# UNITED STATES PATENT AND TRADEMARK OFFICE

APPLICATION NO.	FILING DATE	FIRST NAMED INVENTOR	ATTORNEY DOCKET NO.	CONFIRMATION NO.
10/792,351	03/03/2004	Diana Lynne Gann	9567	4523

<b>Office Action Summary</b>	<b>Application No.</b> 10/792,351	<b>Applicant(s)</b> GANN ET AL.	
	<b>Examiner</b> Michael G. Bogart	<b>Art Unit</b> 3761

## **DETAILED ACTION**

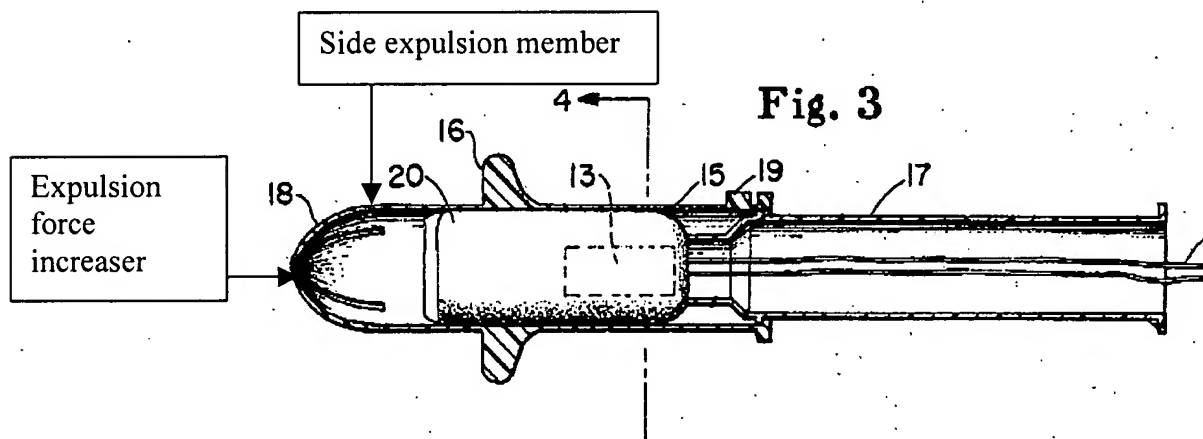
Regarding claims 1, 11 and 14, Kokx teaches a tampon (20) and a tampon applicator (15) in combination for expulsion of said tampon (20) into a vaginal cavity of a female user, comprising:

said tampon applicator (15) comprising a tampon holder tube (15) and a plunger (17);

said tampon holder tube (15) comprising a hollow interior portion, an interior surface, an exterior surface, a longitudinal axis, an outer perimeter, a first end dimensioned for insertion into said vaginal cavity, a second end positioned oppositely to said first end, an end expulsion force increaser positioned at said first end of said tampon holder tube (15), comprising at least one side expulsion member positioned at said first end of said tampon holder tube (15),

said tampon (20) comprising a fluid permeable bag (12) and absorbent material (11) loosely dispersed within said permeable bag (12), said tampon (20) being housed within said hollow interior portion of said tampon holder tube (15) in a pre-expelled position; and

said plunger (17) being slidably mounted in said hollow interior portion of said tampon holder tube (15), said plunger (17) being adapted to expel said tampon (20) through said end expulsion force increaser (see marked figure 3, below).

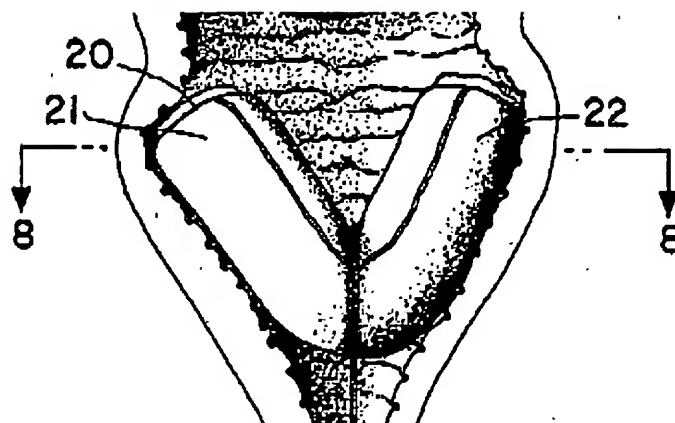
Regarding claims 12 and 13, Kokx teaches that the axis of the tampon reorients itself once it has been expelled (figure 7, below).
